1990 Corvette: Service Bulletin: ABS Code 63 Revised Diagnostic Chart

Subject: SERVICE MANUAL UPDATE SEC. 5E1 ABS DIAGNOSIS-REVISED CODE 63

Model and Year: 1990 CORVETTE

Bulletin Number: 90-430-5 - (08/21/1991)

CODE 63
(PAGE 1 OF 3)
SOLENOID VALVE RELAY
(RELAY FAULT)

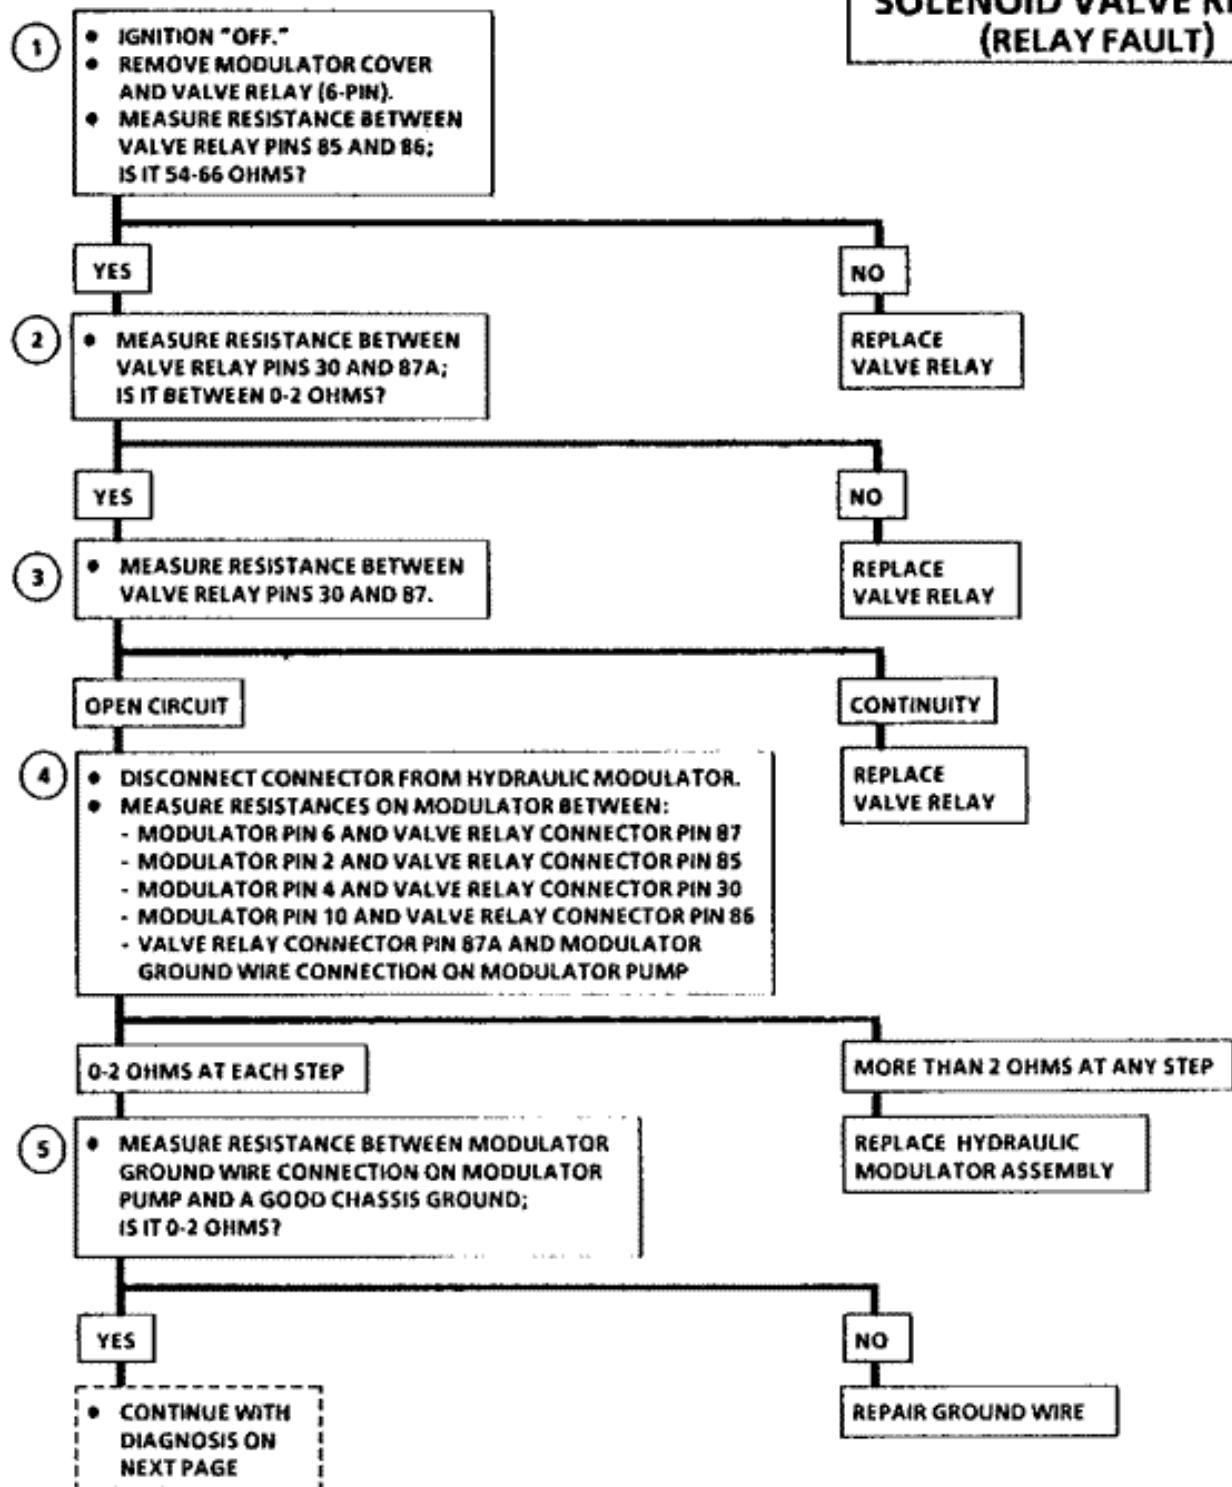
This bulletin serves to update the ABS Code 63 (Page 1 of 3) diagnostic chart on page 5E1-37 in Section 5E1 "Antilock Brake System Diagnosis" of the 1990 "Y" Service Manual. Please use the attached revised Code 63 (Page 1 of 3) diagnostic chart when diagnosing ABS Code 63 conditions on 1990 Corvettes.
